Office Action Summary

10/780,061

LAM, CALVIN

1. This is a first Office action on the merits for application serial number 10/780,061 filed 02/17/04. Claims 1-29 are pending.

Replacement Sheet

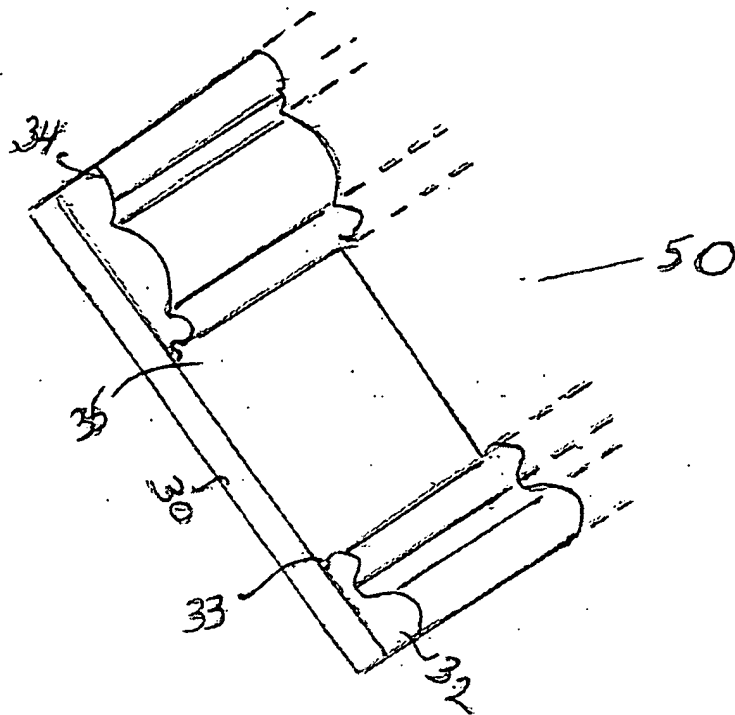
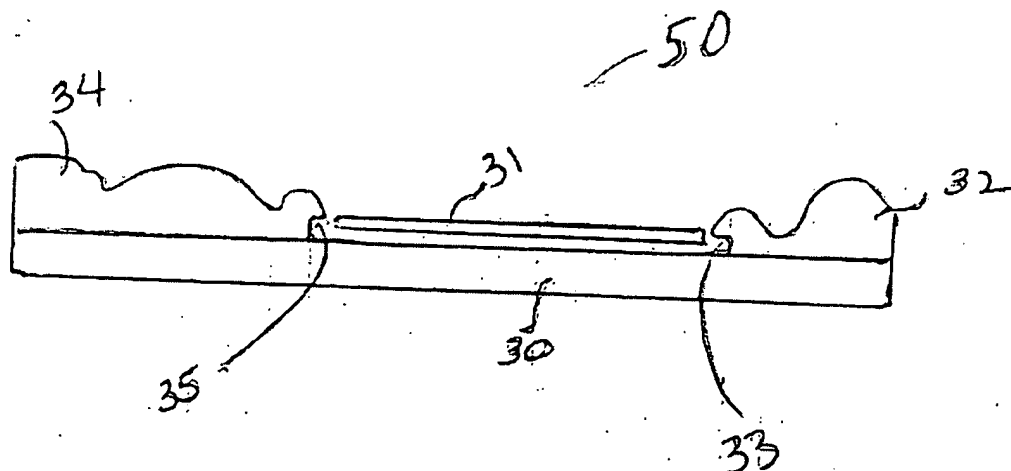
OK
to enter (2)
2/3/06
